IREDELL COUNTY HEALTH DEPARTMENT

IMPROVEMENT PERMIT / AUTHORIZATION TO CONSTRUCT / OPERATION PERMIT / EXISTING SYSTEM INSPECTION

PERMIT# 115353 PIN# 4713-07-3011 DATE 3-31-04

SUBDIVISION W. NASH PROP BLOCK / SECTION LOT 3 LOT AREA 1.46 AC SITE CLASS PS DESIGN FLOW 360 L.T.A.R. .3

INITIAL SITE SKETCH

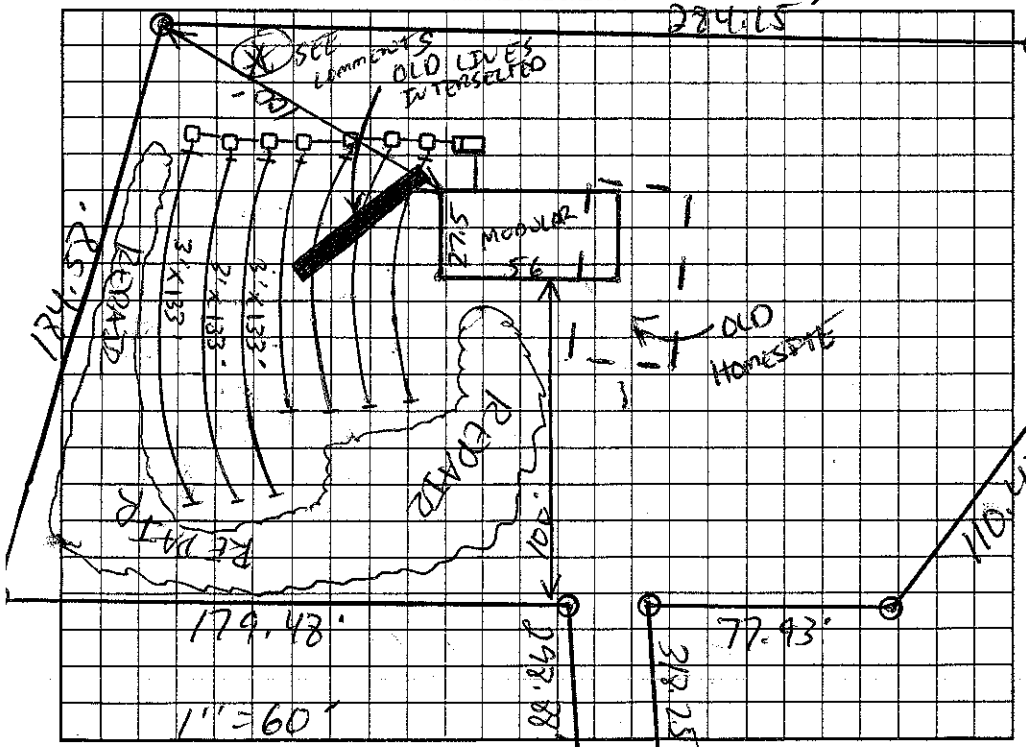
Comments:/Conditions: INSTALLED 5 LINES 30' LONG. 4 OF THE FIVE INTERSECTED THE OLD DRAIN LINES AS DRAWN. INSTALLER DID NOT STOP DIGGING. INSTALLER SAID LAST LINE DID NOT CUT INTO OLD DRAINFIELD. BRADY FREEMAN RS, LORNE LOOK RS &

Comments:/Conditions: WESLEY STARNES RS MET ON LOT & CONSULTED ON LOT. BEST OPTION IS TO FEED WHAT WAS INSTALLED. ADD 50' TO LINE #5 & ADD 2 NEW LINES BELOW IT INSTALLED ON CONTOUR AS DRAWN. TOTAL LENGTH OF LINE WILL BE 400'. IF DURING DIGGING OF NEW LINES ANY OLD DRAINFIELD IS ENCOUNTERED, STOP DIGGING IMMEDIATELY & CALL THE HEALTH DEPT. REPRESENTATIVES FROM THE HEALTH DEPT PROBED EXTENSIVELY IN THE NEW PROPOSED DRAINFIELD AREA & TO OUR BEST JUDGEMENT THE OLD DRAINFIELD IS NOT IN THE NEW DRAINFIELD AREA. UNITED MODULAR HOMES REP. BOB HADEN AUTHORIZED THE CHANGES VIA PHONE CALL 3-31-04.
